**U.S. ARMY WEAPONS COMMAND
DEPOT MAINTENANCE WORK INSTRUCTIONS
FOR
Overhaul Of The Machine Guns, 7.62MM:
M60 And M60C**

SUBJECT: Repair of Butt Stock M60 Machine Gun USAWECOMDMWI
1005-224 Change #8

Remove from subject DMWI, Figure 31 and all associated illustrations of Change #3. Insert new legend and Figures 31 through 31F.

FIGURE 31A

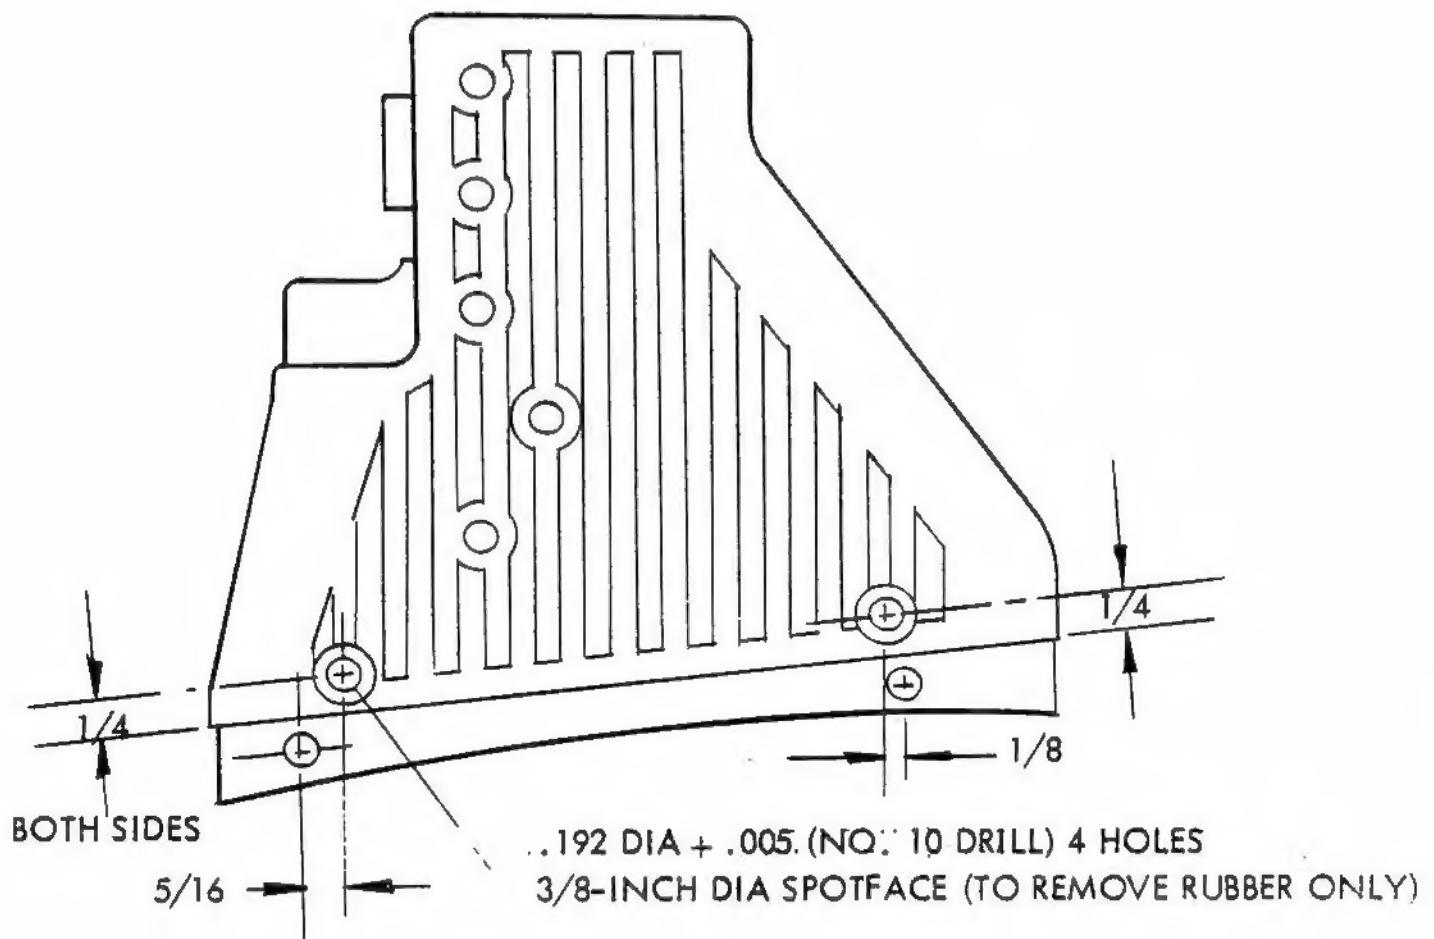
5. Fabricate (2) reinforcing plates in accordance with Figure 31.
6. Locate (4) .192 + .005 diameter holes as indicated in Figure 31A. Drill through from each side. (Use No. 10 drill). Suggest reinforcing block of approximately 1.500 inch height be used between sides of butt stock frame during drilling and spot facing operations to avoid distortion caused by pressure.

7. Spotface (4) locations, to required 3/8 inch diameter. Exercise care to remove only rubber coating. (See Figure 31A).
8. Assemble as shown in Figure 31B. Clamp plates securely in location.

FIGURE 31B

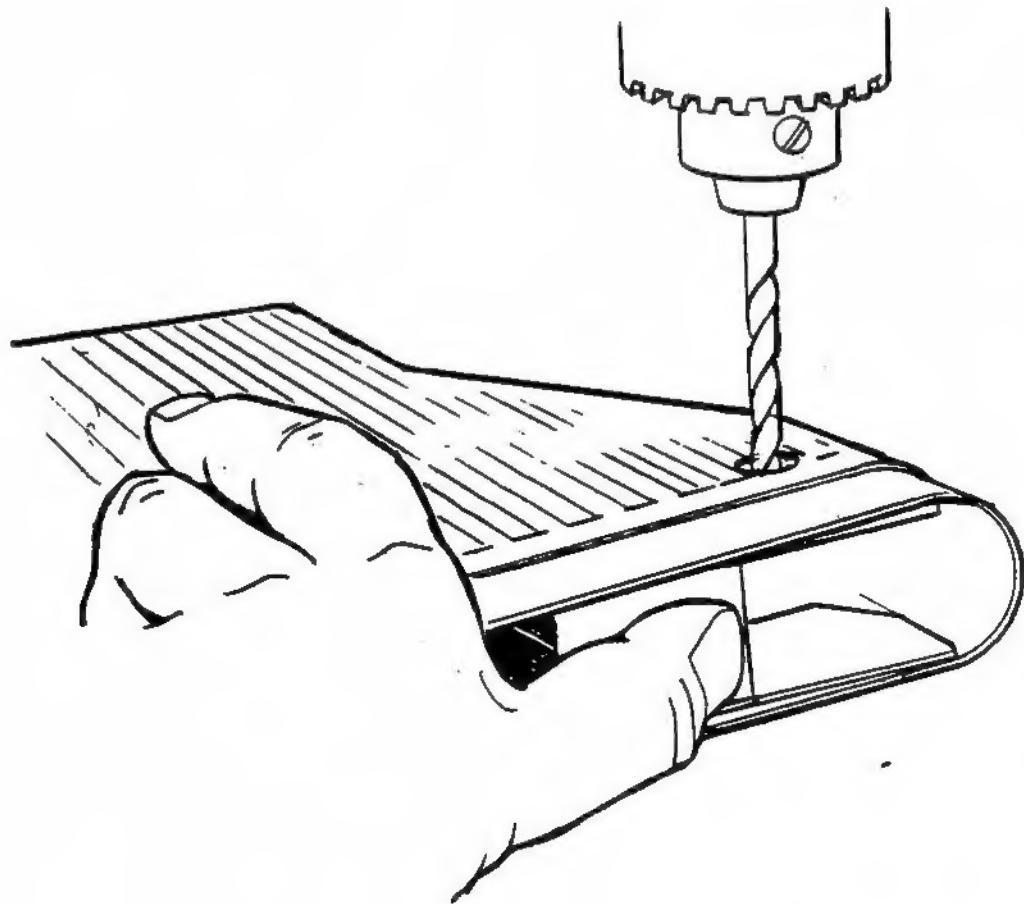
9. Drill (4) .195 + .005 inch diameter holes, two from each side, through fabricated plates using holes drilled in operation to above as a guide. (See Figure 31B. Note suggested separator block of approximate 1.400 inch height).

USING HOLES IN BUTT STOCK FRAME FOR A GUIDE, DRILL (2) .192 + .005 INCH DIAMETER HOLES (NO. 10 DRILL), THROUGH THE UPPER PLATE ONLY. TURN ENTIRE ASSEMBLY OVER AND REPEAT PROCESS FOR THE REQUIRED (2) HOLES ON THE OTHER SIDE. DURING DRILLING IT IS SUGGESTED THAT A SEPARATOR BLOCK OF APPROPRIATE HEIGHT (APPROXIMATELY 1.400 INCH), BE PLACED BETWEEN THE FABRICATED PLATES TO AVOID DISTORTION CAUSED BY PRESSURE DURING DRILLING.

FIGURE 31E

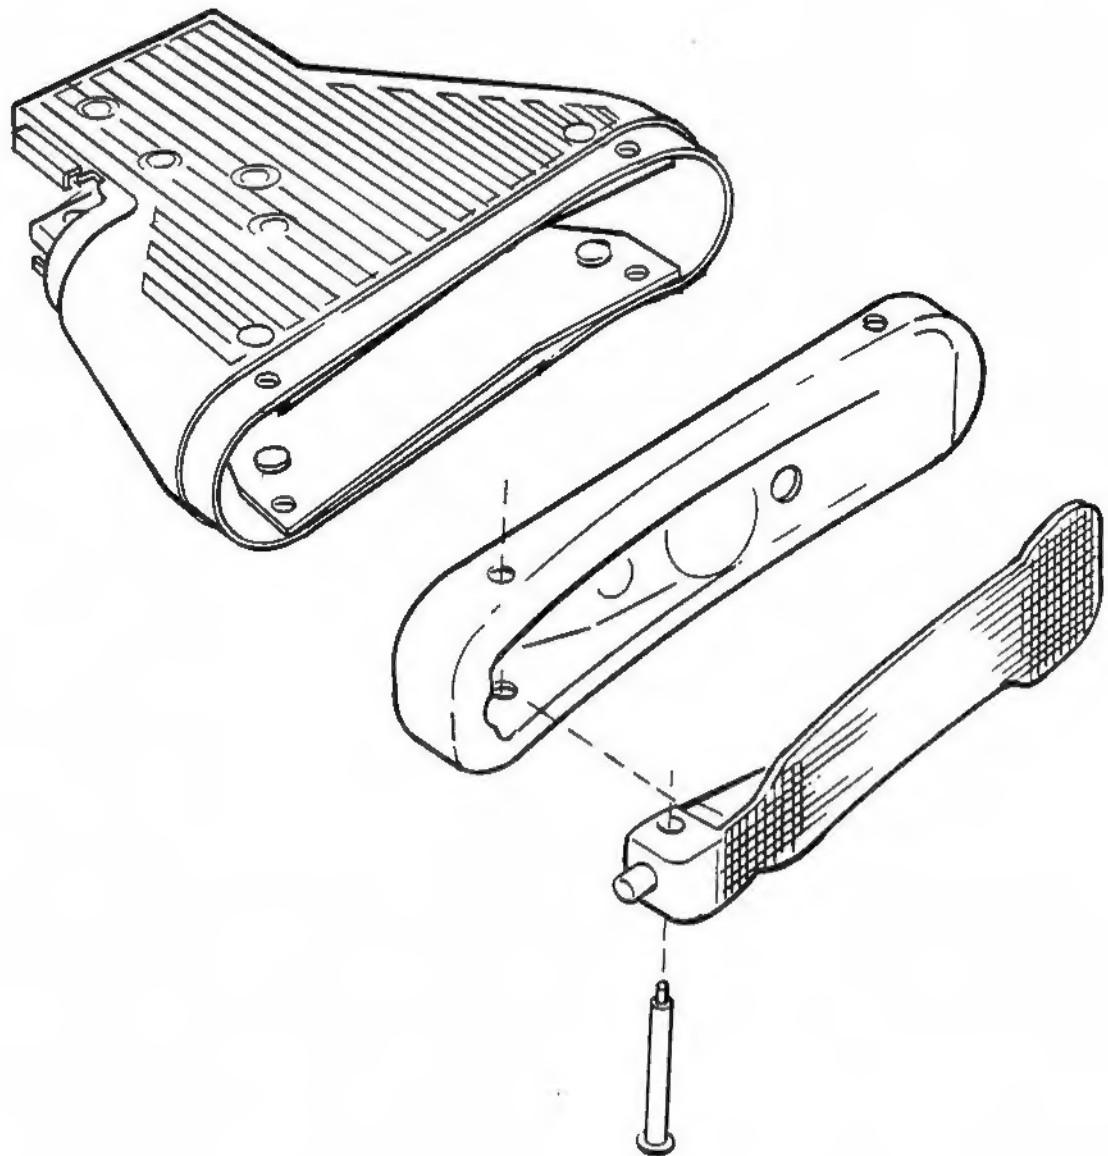
13. Place shoulder rest in butt stock plate assembly.
Install in butt stock frame and rivet in location. (See Figures
31E and 31F).

FIGURE 44

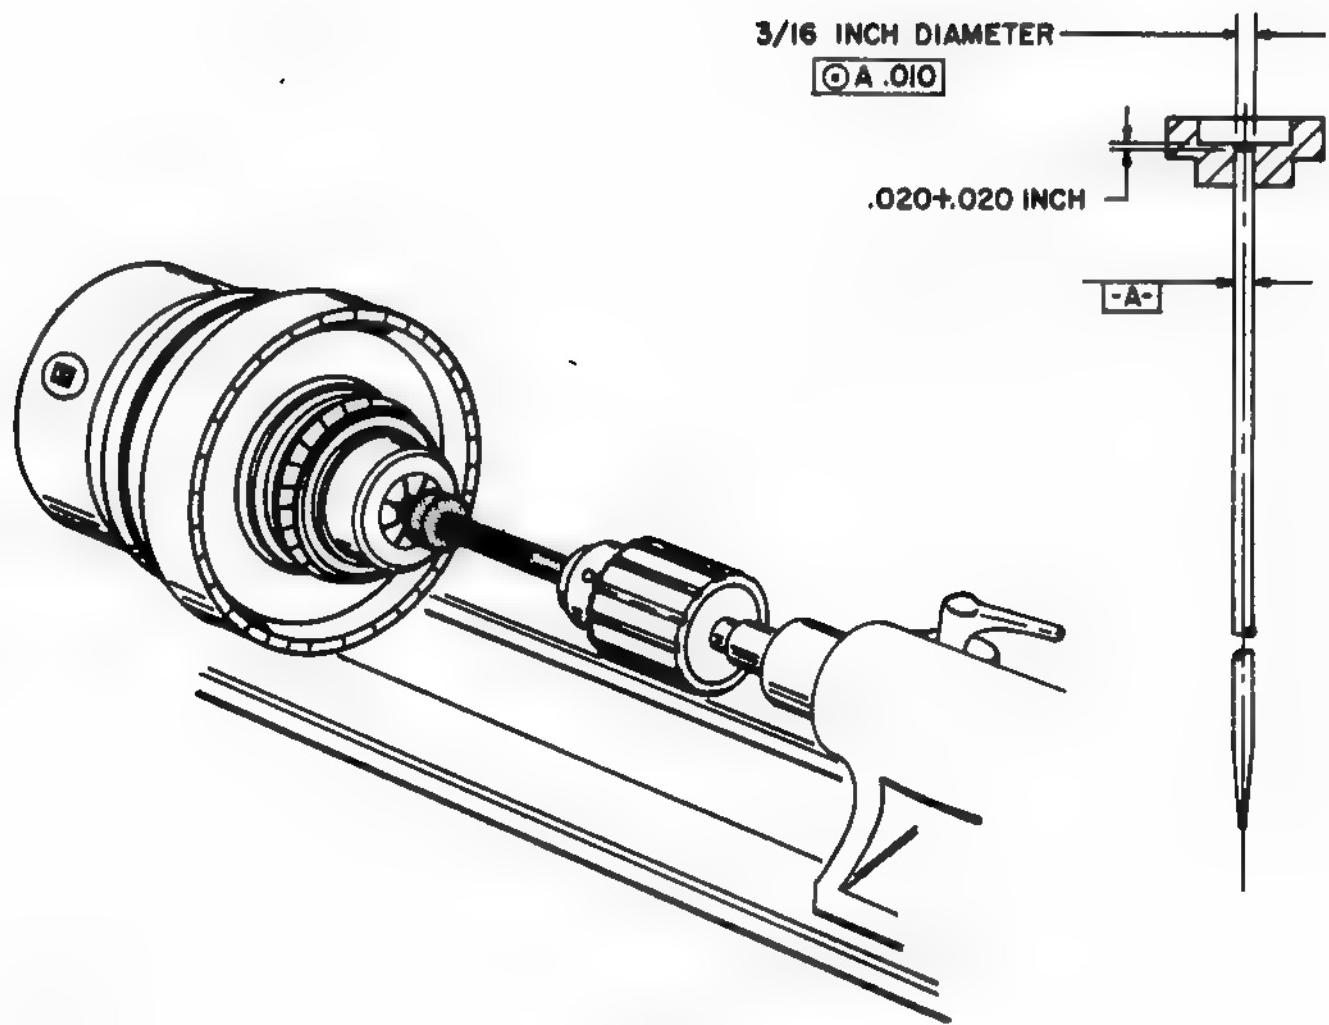
1. Paragraph 6.9.6.3.5 (b) is considered restrictive pertaining to Machining Method of application of underput required by OIP7269199. (Reference Figure 44 also).
2. Pen and ink change shall be made to above paragraph as follows:

- (a) Insert rod in lathe chuck and secure.
- See Ch #6 for ref.* (b) ~~Using a 3/16 inch two lip end mill, recut rod to dimension and requirements shown in figure 44.~~ *"machining method optional".*
- (c) Remove from lathe.
- (d) Remove burs.
